DTP Community Reference Group STATEMENT OF ADVICE

Activity Centres

Hawksburn to Malvern & Toorak Village

22 March 2026

3A. HAWKSburn - KEY CONSIDERATION NO. 1 – THE CATCHMENT BOUNDARIES

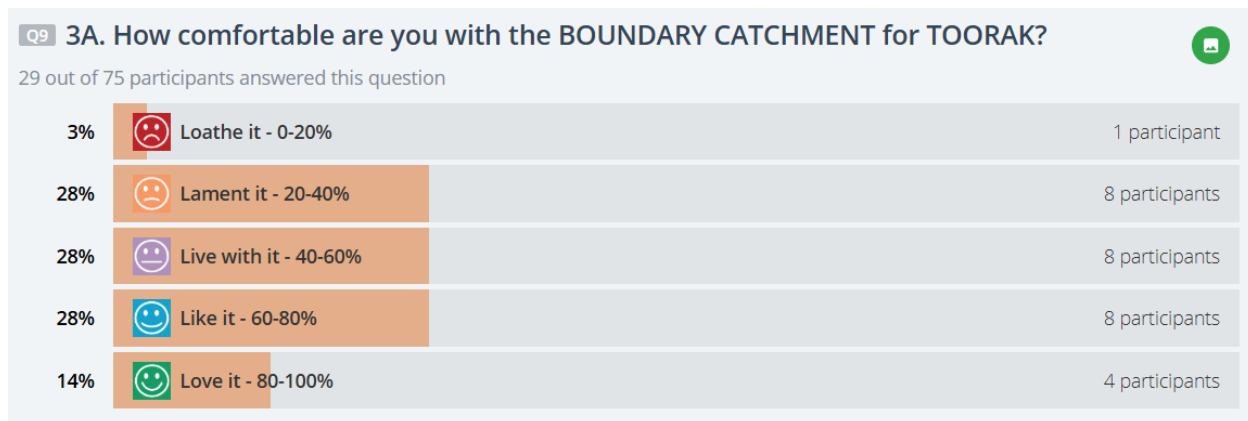
We often said the “inner catchment is too big” and includes areas that “don’t make sense,” especially low-rise residential streets. Most of us suggested reclassifying Hawksburn as outer catchment, while others noted inconsistencies in zoning. There was a shared feeling that the boundary does not reflect how the area actually functions.

Some of us said higher density should be focused “around Hawksburn Station” and along key transport corridors, while others said the height should be no more than 2-4 stories due to the narrow streets and current shortage of parking in this area. Some of us felt the current boundary is too focused on the commercial strip instead of the station, which “counters the purpose” of the program. There were suggestions to expand the core at the station and reduce density in the remaining area.

We described Hawksburn as “predominantly 1–2 storey dwellings” with a “fine-grain streetscape” and “heritage qualities.” Many of us said applying mid-rise development directly into these streets creates a “hard edge,” with “bulk and massing out of proportion” and loss of openness and greenery. We expected a more gradual transition between different scales.

We said we “don’t understand the rationale” for inclusions and exclusions, including why some areas without heritage overlays are left out while others are included. There were also questions about why there are “two separate catchments” and how decisions have been made. This lack of clarity reduced confidence in the approach. The group expects more nuance in catchment inclusion for existing streetscapes.

We suggested that higher density should be located along “Malvern Road” and other major corridors, or on sites that can accommodate change, while taking into account the impact of six plus storey developments on surrounding residential homes. Some of us pointed to opportunities for mixed use or redevelopment in specific areas rather than spreading density into smaller residential streets.

3B. TOORAK - KEY CONSIDERATION NO. 1 – THE CATCHMENT BOUNDARIES

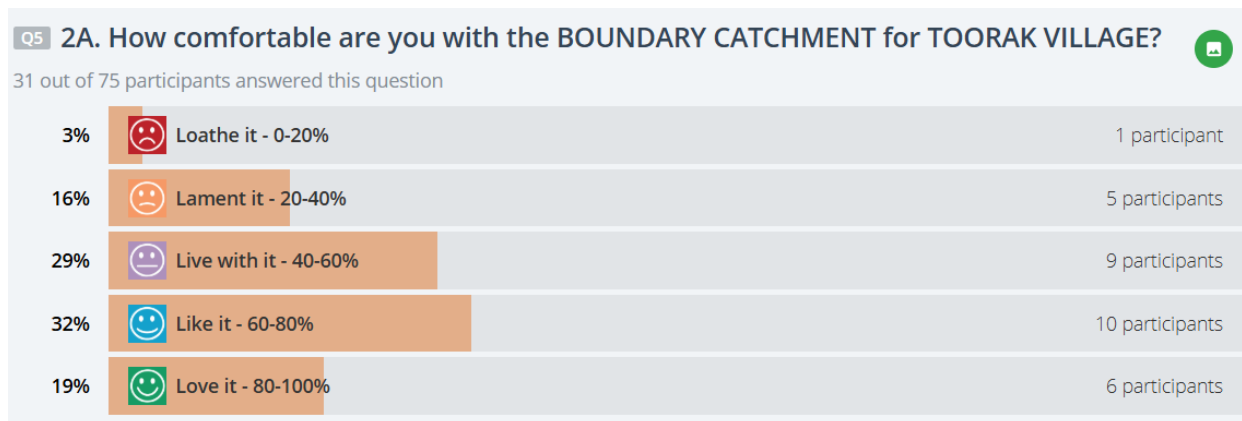
Across the group, views ranged from very supportive to opposed, including one strong opponent. Members of the community felt that in some areas the core zone seemed smaller than it could have been. Specifically, both north and south sides of Malvern Rd to the east of Orrong could have been included, linking with the Hawksburn village core, and the south side of Malvern Rd east of Orrong road to Clendon Rd could be included without diminishing local amenity. This recommendation would include additional retail and commercial, extending the Hawksburn shops toward Toorak station. These recommendations were not unanimous.

Others felt the boundaries were appropriate, and it was sensitive and positive that areas like Beatty street were excluded from the proposed core. Some viewed that the boundary should be moved yet closer to the stations, and density is most appropriate close to Toorak station.

Some respondents questioned why inner and outer catchment areas were necessary; why some heritage areas are included, and why certain places like Beatty Avenue or areas south of the Toorak Village are treated differently. There was also curiosity as to why Mandeville Hall, a long-established school, was being zoned for density. Some respondents said there is a “lack of understanding of the area” behind the boundaries.

Some respondents suggested specific extensions along “Orrong Road,” “High Street,” and areas near Millicent Avenue and Maple Grove, but others raised strong objections to this extension. These ideas focused on logical edges and places already connected to activity or transport. These areas could be made outer catchment, rather than not being incorporated at all. Some people think these areas have a higher incidence of large blocks of land and wider roads, although that depends on the comparison.

3C. TOORAK VILLAGE - KEY CONSIDERATION NO. 1 – THE CATCHMENT BOUNDARIES

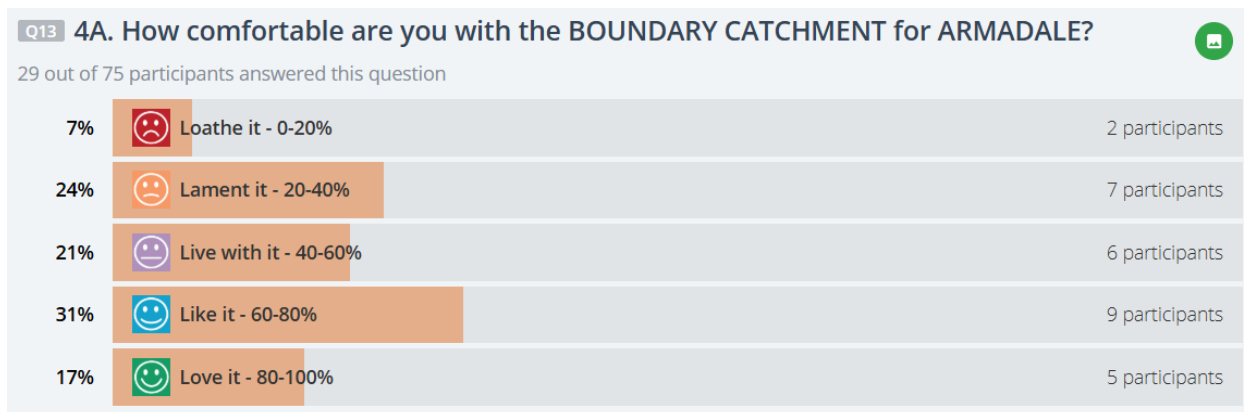
Some said areas south of the core or along “tram route 58” should be inner catchment, not outer. This is specifically relevant on Mathoura Road and perhaps around Carter Avenue. Any increased density in this area must take into consideration the impact additional traffic may have on small local streets, and adjust the catchment boundaries accordingly. There was a clear view that density should be concentrated closer to shops and activity, not spread more broadly.

We said the “inner catchment [is] far too extensive” and includes areas that don’t suit higher density such as north of Douglas St and West of Wallace Avenue where they would overlook the junior school of Geelong Grammar School along Jackson St. At the same time, some areas closer to the centre were seen as incorrectly placed in the outer catchment.

Some of us said the boundary “doesn’t make sense” in parts or lacks clear rationale. For example, north of Toorak Road Inner Catchment extends well beyond Toorak Road, while on the south side Inner Catchment only extends around 100 metres.

Should the area between Woodside Crescent and Gordon Street be considered as Inner Catchment due to close access to Hawksburn Station?

3D. ARMADALE - KEY CONSIDERATION NO. 1 – THE CATCHMENT BOUNDARIES

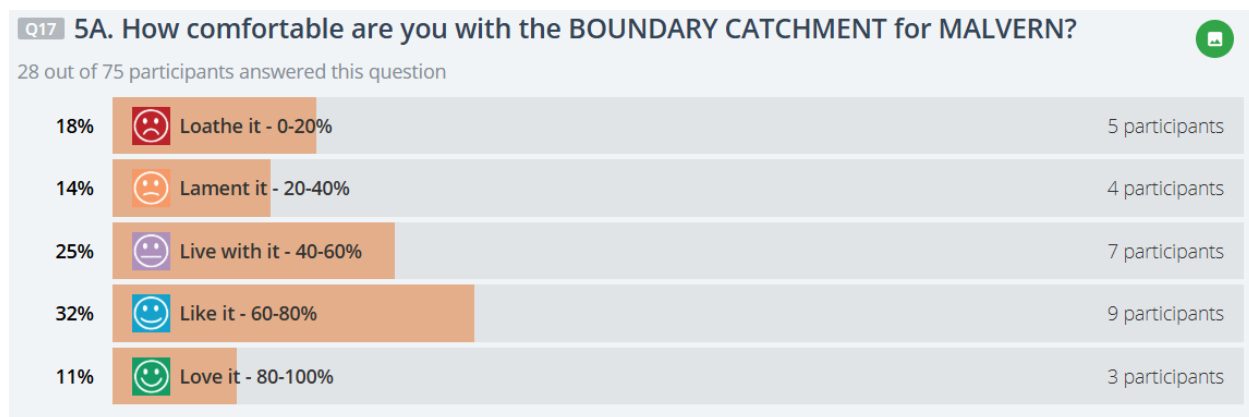
We repeatedly said the inner catchment between Malvern Rd and Wattletree Rd “is too wide” and extends into streets that “cannot manage increased density.” There were concerns about spreading density too far into residential areas (centred between main roads), with suggestions that many of these areas should instead be outer catchment (3-4 storeys) compatible with the surrounding areas.

We said the core should be “expanded more around the trapezium block on Kooyong Rd, and the area between Clarendon st and High st” as well as along the west of High Street towards Orrong Rd, particularly to support public transport use. There was a consistent view that density should be concentrated in these areas rather than distributed broadly.

We said areas without heritage overlays and with good access to transport should be prioritised for higher density. At the same time, we emphasised protecting heritage streets where appropriate and using them to guide where boundaries should or should not extend, as well as repurposing heritage buildings for multigenerational use, or using facades of heritage or other existing blocks and extending up.

We questioned why some areas are included or excluded, such as specific blocks or streets, and said the rationale is not clear. There were suggestions to extend boundaries along logical corridors like High Street towards Orrong Road.

3E. MALVERN - KEY CONSIDERATION NO. 1 – THE CATCHMENT BOUNDARIES

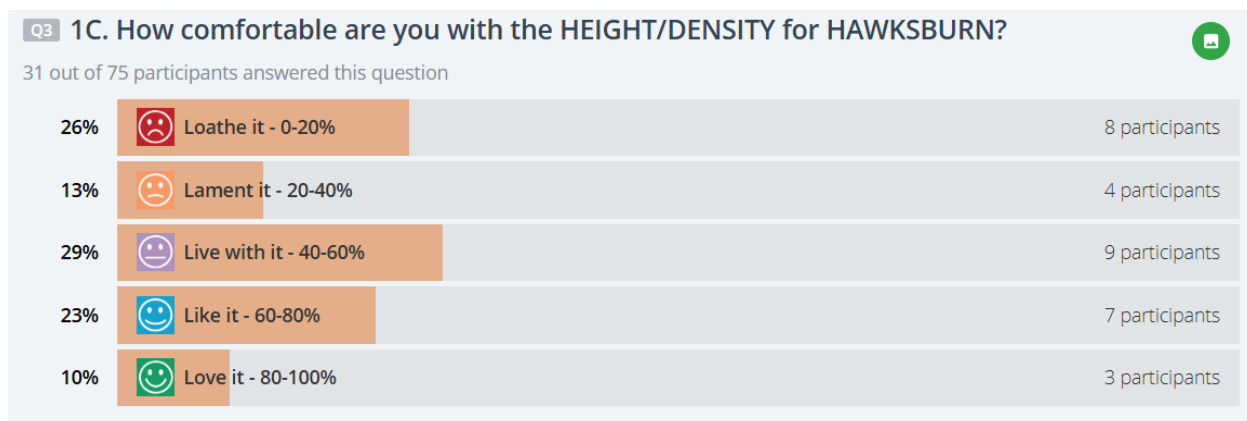
A view that the South side of Dandenong Road from Hawthorn Road West to be included as Inner Catchment. This is supported by the transport availability on Hawthorn Road and Dandenong Road.

We said the “inner zone is too large” and includes areas “that don’t make sense,” particularly where they are far from stations or dominated by heritage.

Limit Inner Catchment only to property blocks that front the arterial roads (Malvern Road, High Street). Limit Inner Catchment to major roads and not smaller streets.

We said core catchment around the Malvern Station is appropriate to better use the Frankston line, including the south of Dandenong Road around Hawthorn and Balaclava Roads. There was also support for the current practice of concentrating density along arterial roads rather than spreading it broadly.

We questioned why some areas such as the area to the southwest of Dandenong Road around Hawthorn and Balaclava Roads are excluded while others are included. There was a sense that the boundary “doesn’t make sense” as that corner, in particular, is a transport hub. The boundary lacks a clear, consistent rationale. Dandenong Road, although a highway, has a lot of foot passage from North Caulfield because of the Malvern station. Specifically, the area of interest is bounded by Hawthorn Rd, Balaclava Road, Kooyong Road and Dandenong Rd.

4A. HAWKSburn KEY CONSIDERATION No. 2 – BUILDING HEIGHTS AND DENSITY

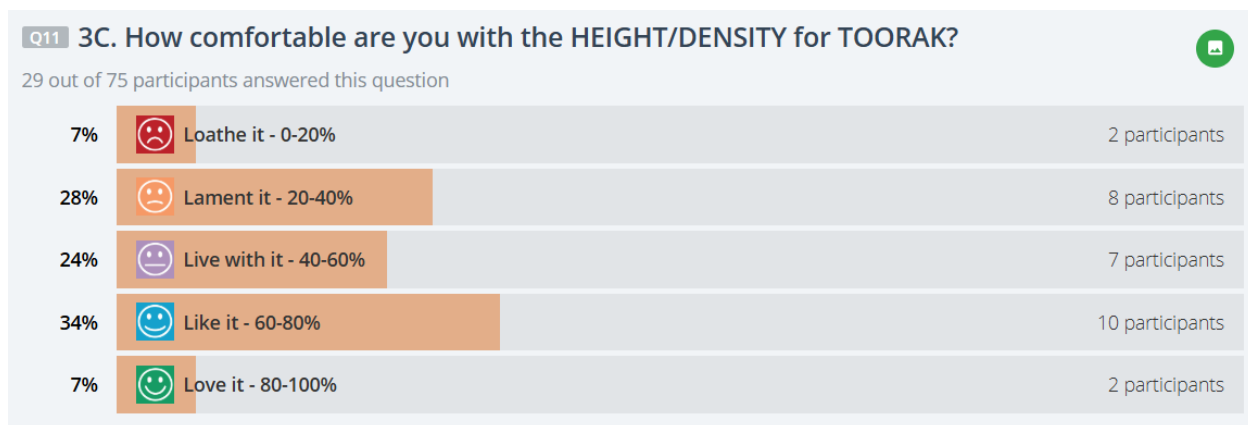
We often said we support “higher density near the train station” and along places like “Malvern Road.” Some of us wanted the station itself to be treated as the core with more intensity there. At the same time, we questioned why higher heights are not more directly focused “immediately adjacent to Hawksburn Station” subject to heritage considerations.

Many of us said “the proposed heights are too high,” especially in the catchment and residential streets. We described the area as “predominantly 1–2 storey” with a “fine-grain / green canopied streetscape,” and felt 4–6 storeys represents a “step-change in built form” that is “out of character.” Much of what is currently inner catchment should be outer catchment.

We repeatedly said the issue is “lack of transition.” The current approach introduces mid-rise development “directly into low-rise residential streets,” creating a “hard edge between incompatible built forms.” We expected density to step down more gradually from core areas. Some of us said that high rise (six plus storey) developments on main roads will impact the privacy and visual openness on adjacent residential homes - particularly at the rear.

4B. TOORAK KEY CONSIDERATION No. 2 – BUILDING HEIGHTS AND DENSITY

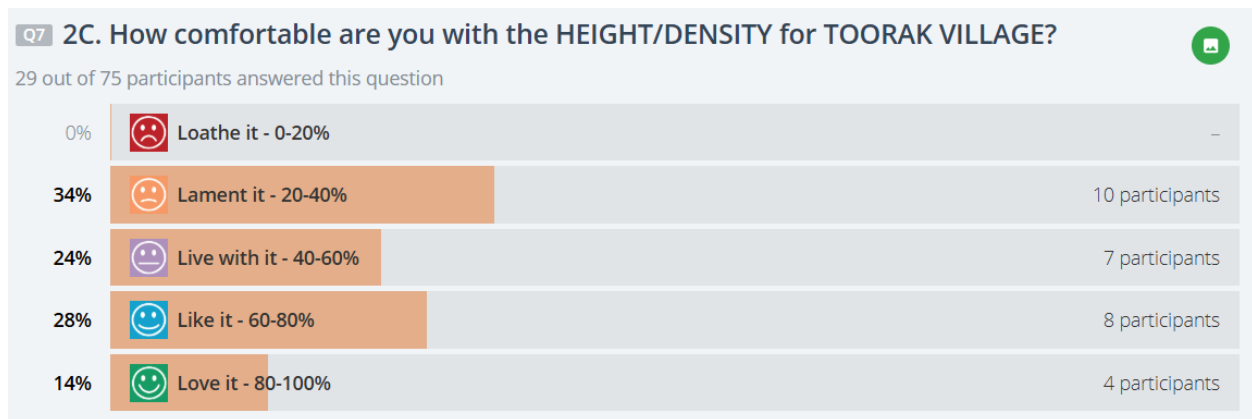
Some repeatedly said heights should be higher “closer to the station” and along “Orrong Road” and “High Street,” with density stepping down away from these areas. There was some support for expanding the core around the station. Some felt that all inner catchment (four storey) should be reduced to outer catchment (three storey), while others suggested extending the outer catchment areas into the streets north of Malvern Rd and east of Orrong Rd.

Some respondents felt that the ‘core’ was entirely inappropriate, and development should be held to a four-storey limit around stations, with the entire catchment limited to three-storeys. This was not unanimous.

A respondent felt the area west of the railway, south of Malvern road, could support higher heights, akin to the mixed heights currently built in the Toorak Park development

4C. TOORAK VILLAGE KEY CONSIDERATION No. 2 – BUILDING HEIGHTS AND DENSITY

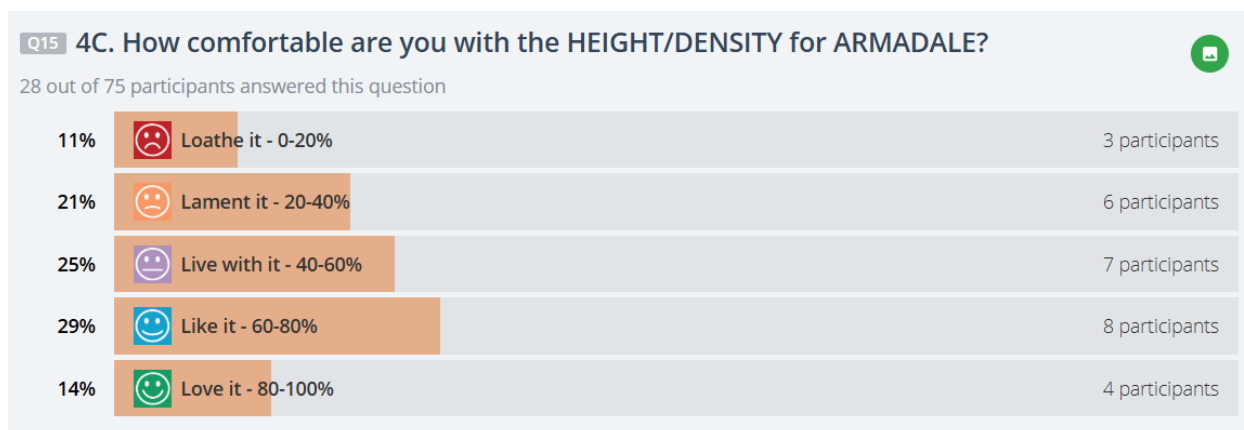
There was a clear view that higher buildings within the core boundary do not spread into surrounding streets.

We noted there are already “quite a few high rise” buildings and that roads like Mathoura can support Inner catchment zoning to “support height and density.”

We are very concerned about the impact of high rise buildings in the core on adjacent residential buildings in the surrounding areas with respect to impacts on privacy/overlooking and scale.

4D. ARMADALE KEY CONSIDERATION No. 2 – BUILDING HEIGHTS AND DENSITY

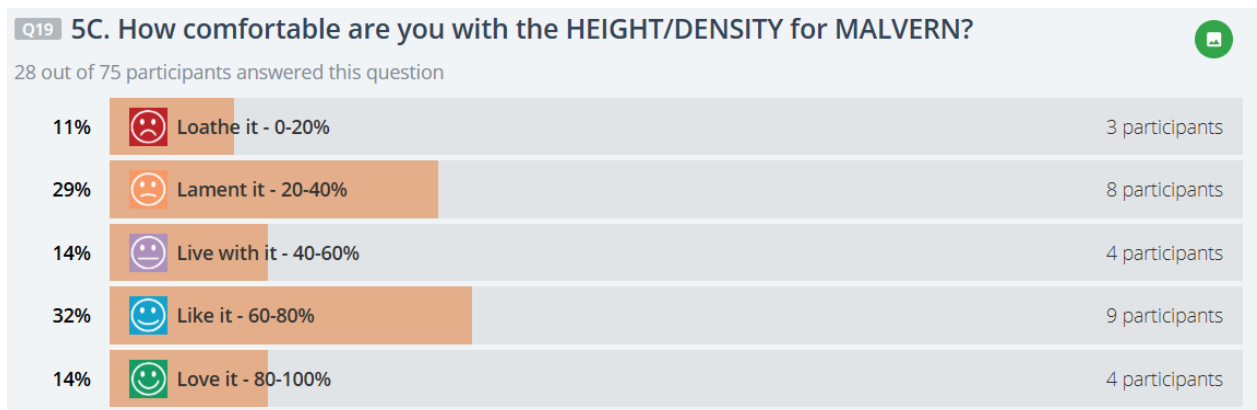
There was general agreement on the core boundary and the proposed height limits set. In addition, the core boundary should be extended along “the main road of High Street west towards Orrong Rd”, on the west side of Kooyong Rd near Armadale Station north of the train line, and encompassing the north side of Clarendon St. At the same time, many of us said areas away from these corridors should remain lower scale to keep the light and character of these areas.

There was a difference of opinions, with some repeatedly said there should be “no higher than 3 storeys” or “maximum of 4 storeys” in inner catchment residential areas. There was strong concern about extending 4–6 storey buildings into “1–2 storey dwellings” and heritage streets.

4E. MALVERN KEY CONSIDERATION No. 2 – BUILDING HEIGHTS AND DENSITY

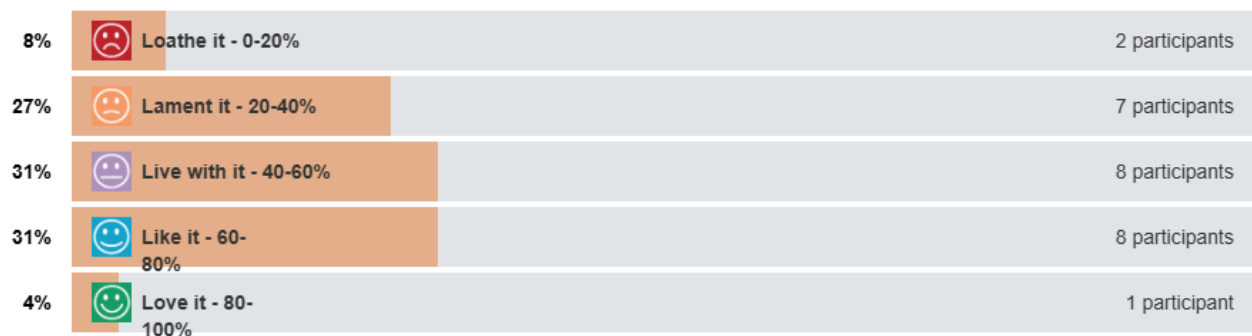
Some of us said the approach is “fine,” “appropriate,” or “consistent with current development.” Proposed high-rise sites seemed acceptable but more objection to Inner Catchment zoning heights away from the main roads (Glenferrie, Dandenong, Wattletree, High).

We said “10–16 storey buildings” are “excessive” and would create “wind tunnels” and “random towers.” There was concern these heights would not fit the suburban context and would dominate surrounding areas. The height limit on the higher building heights (Coles, Dan Murphy’s and Malvern Central) should be lowered and the rest of the core (buildings along Glenferrie Road) should be increased for consistency along the streetscape. All buildings within the core should be brought up to a blanket height of 6-8 storeys, with no differentiation between sites.

We said more density should be focused “around the Malvern Station,” especially to utilise the Frankston line. One person supported higher buildings along Station Street, rather than spreading density across the whole area.

There is no need for increased setbacks in north facing properties on Wattletree Road (on south side of the road). There are no over shadowing impacts to neighbours and removal of the ‘building setback further from the street’ will ensure building bulk is not pushed southwards towards smaller properties.
